**Flexible Resource Adequacy Criteria and Must-Offer Obligation
Draft Final Proposal Stakeholder Comments**

Figure 1: Regulation as Component of Flexibility

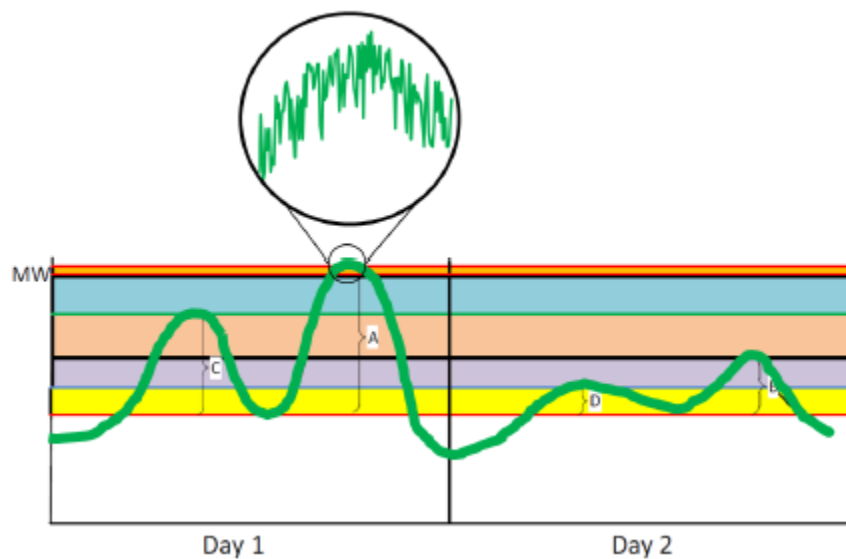
Under the CAISO's current market rules, a REM resource can provide regulation continuously for the entire Must Offer Obligation window from 5:00 pm to 10:00 pm. Such a resource could not only provide regulation over the entire duration, but it also contributes directly to the 3-hour maximum ramp, as is shown below in Figures 1 and 2.

Category 1 resources must be able to meet the net ramp energy requirement. Because REM resources provide regulation and not energy, it is not appropriate to qualify REM resources to meet the most stringent flexible category that was created to ensure the bulk of net load energy needs were met.

Figure 2: 100 MW Peaker vs. 100 MW Peaker + 25 MW 15-Minute Energy Storage

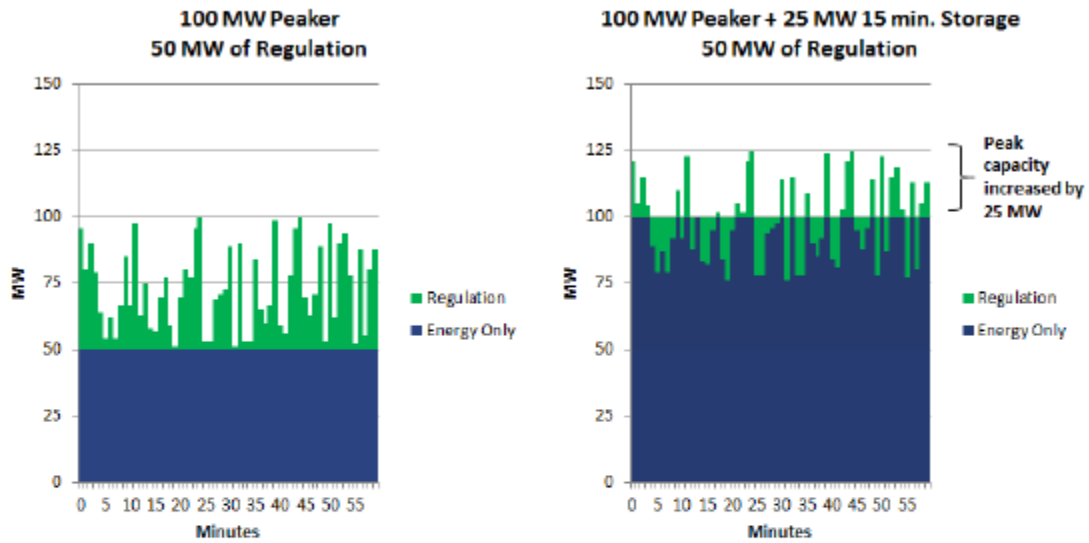
As is shown above in Figure 2, the REM resource demonstrably contributes to peak capacity at its full regulation capacity.

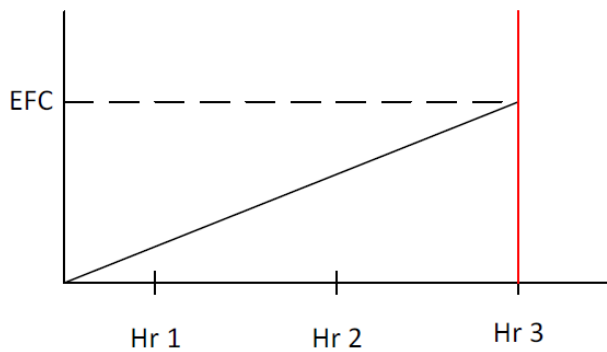
For storage electing to provide fully flexible capacity, the ISO now proposes to determine the effective flexible capacity (EFC) of energy storage resources based on the MW output the resource can deliver after three hours of discharge at a constantly increasing discharge rate (1.5 hours of energy capability over 3 hours). Previously, storage was required to deliver 3 hours of energy over 3 hours.

The figure below from the ISO Proposal illustrates this determination of EFC for storage to qualify as fully-flexible capacity. It means that only 1.5 MWh of energy storage per MW (1.5 hours) of storage is required and longer duration storage receives no additional EFC credit.

Most storage and especially fast storage that can provide the most flexibility to the ISO market can respond almost immediately. Applying a reduced, low ramp rate to storage below its capability makes no sense.

The ISO will determine the EFC of energy storage resources selecting the full flexible capacity option based on the MW output range the resource can provide over three hours of charge/discharge at a constantly increasing discharge (i.e. constant ramp rate). Storage resources selecting the full flexible capacity option will be required to submit economic energy bids for the time period applicable to the category for which they are shown for flexible capacity and may not be listed as a regulation energy management resource in the ISOs Master File. The ISO believes that a clarification consistent with what NGK is suggesting has been made in the revised draft final proposal (i.e. energy storage resources providing category one flexible capacity must be able to provide six hours of energy in a day). If the resource is registered as an NGR resource, the ISO would be able to address any charging and discharging requirements through the market optimization. This is further described in section 6.
